SERVICE

1A2 KEY TELEPHONE SYSTEM
597- AND 598-TYPE PANELS

1.001 This addendum supplements Section 518-215-417, Issue 5. Place these pink sheets ahead of Page 1 of this section.

1.002 This addendum is issued to add information on the following KTUs:

TABLE A

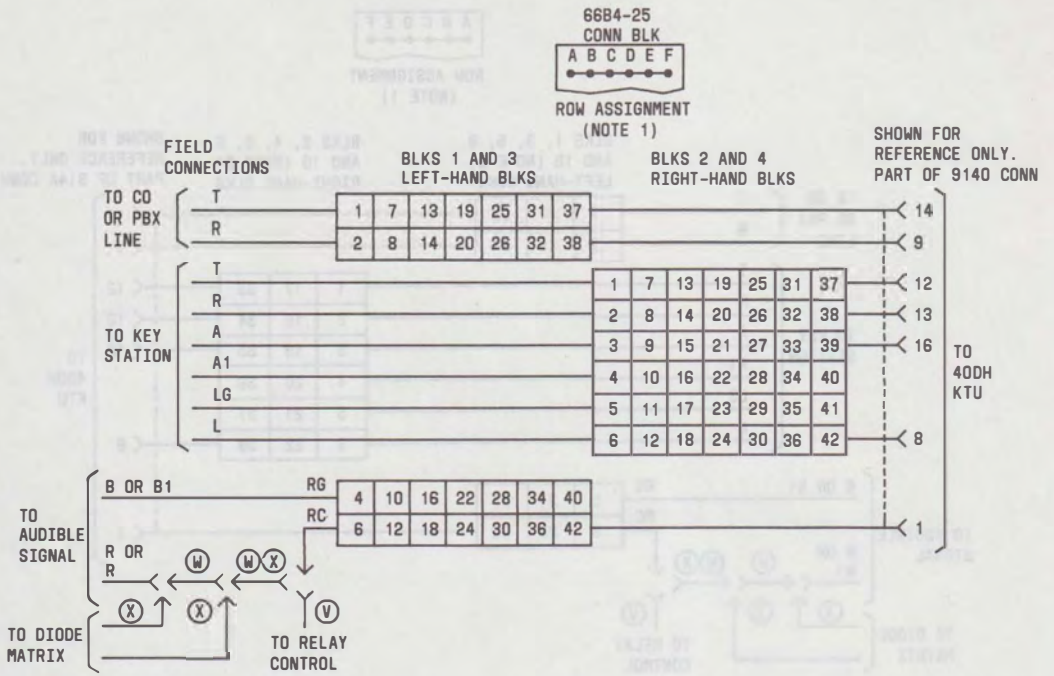
2.001 On Page 4, Table A is revised to show the addition of the 400H and 498A KTUs. A revised Table A is shown in this addendum.

Fig. 10.1—Nondedicated Lead Connections for 400H KTU (CO or PBX Line Circuit) in 597-Type Panel

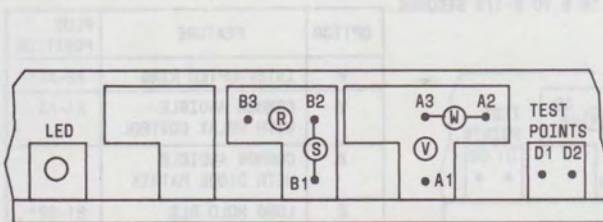
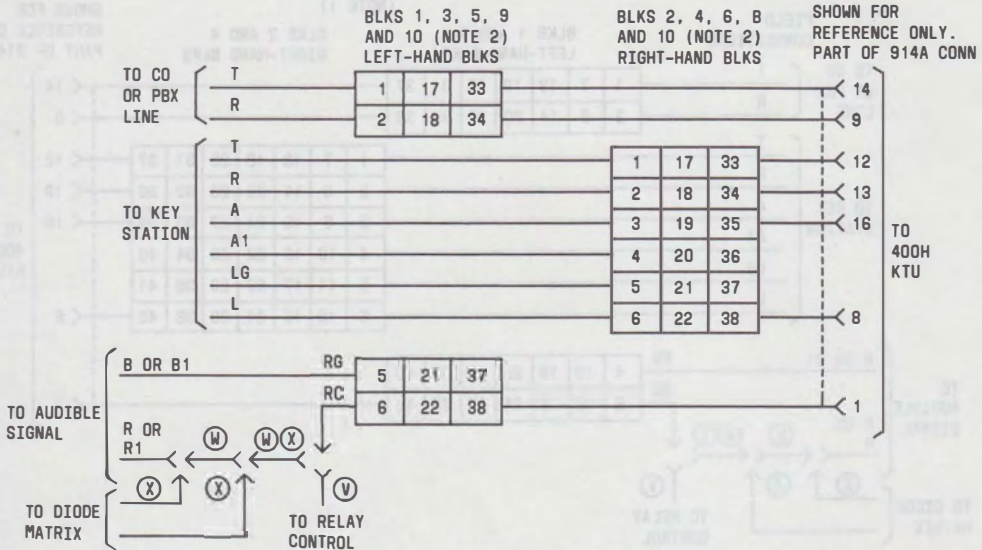
Fig. 10.1—400H KTU (CO or PBX Line Circuit)

2.005 On Page 15, add Fig. 10.1.

Fig. 27.1—Nondedicated Lead Connections for 400H KTU (CO or PBX Line Circuit) in 598-Type Panel

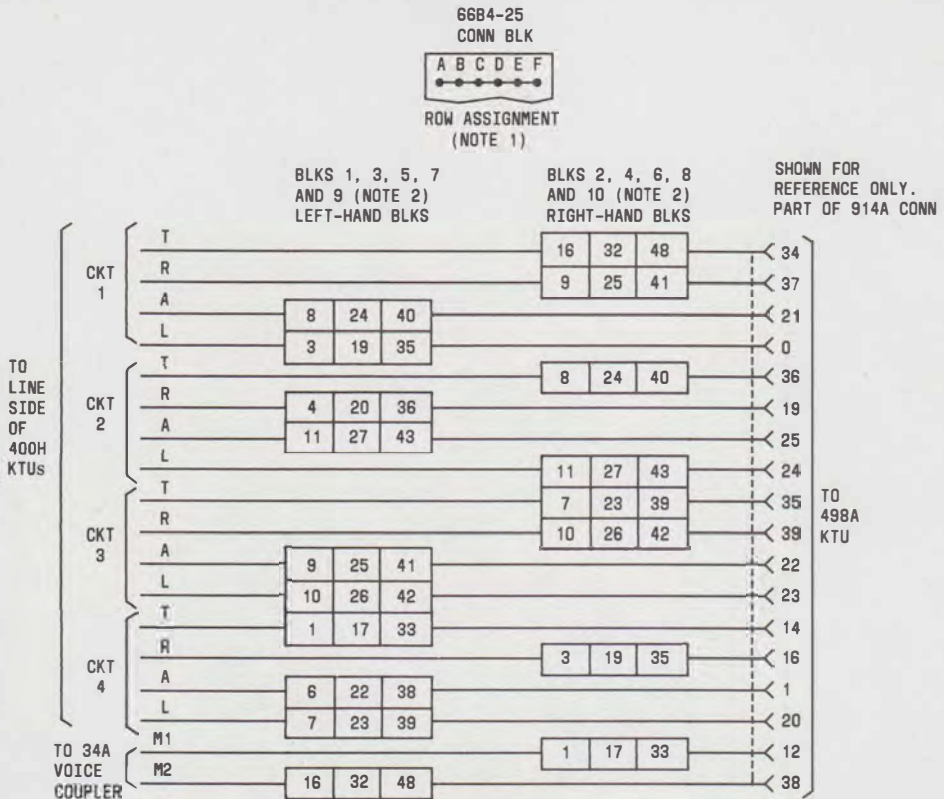
Fig. 27.1—400H KTU (CO or PBX Line Circuit)

2.006 On Page 32, add Fig. 27.1.
